TO: Neil Bhargava, Sr. Project Manager/Executive
 Neeser Construction, Inc.

FROM: Henry Ashburn, Senior Consultant
 McKay Conant Hoover Inc

SUBJECT: SCF PCC1, PCC2, PCC3 HVAC – Acoustic Site Observation
 MCH Project #26002

DATE: 10 February 2026

Figure 4: RTU 2.1 Vertical Discharge and Connected Ductwork

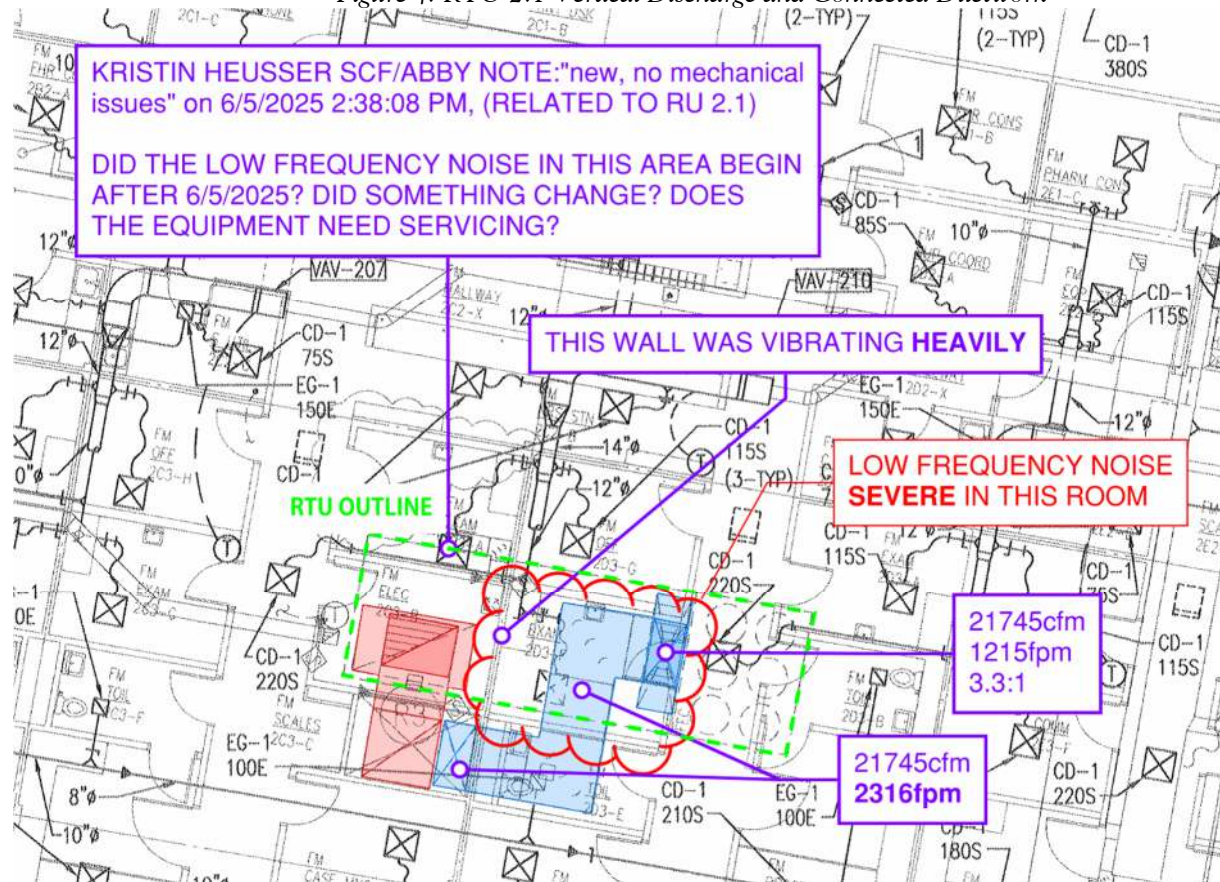
- e. The low-frequency noise fluctuated randomly, suggesting the primary noise source may be turbulent airflow. Drawings indicate very high airflow velocities and multiple abrupt airflow direction changes (see Figure 4).

- f. Ensure the fans, motors, and other equipment within the RTU are properly maintained, balanced, and adjusted for proper operation.
- g. Ensure vibration-isolation systems (new or existing) are properly selected for the operating weight of the equipment and are properly installed. Ensure spring isolators are correctly adjusted. If spring isolators were improperly selected for the fan/equipment weight, consider replacing them with new units providing the proper minimum static deflection under load.
- h. Reduce RTU airflow delivery as much as possible while still providing the required amount of air to occupied spaces, and then rebalance the system.
- i. Reconfigure ductwork to be much smoother and/or less restrictive. This may involve modifying duct dimensions, locations, lengths, or turning-vane configurations, or slightly

shifting the RTU during reinstallation and reconfiguring the unit for horizontal discharge instead of vertical discharge. For reference, other RTUs do not force full-RTU-quantity airflow at the unit discharge through four consecutive elbows in quick succession at 2,300 fpm+. Consider mimicking other, quieter RTU discharge ductwork schemes. Consider 45° diagonal duct runs to minimize the number of 90° turns. Turning vanes sometimes add to airflow turbulence issues when located at the unit discharge. Consider removal of vanes, if possible from a mechanical standpoint.
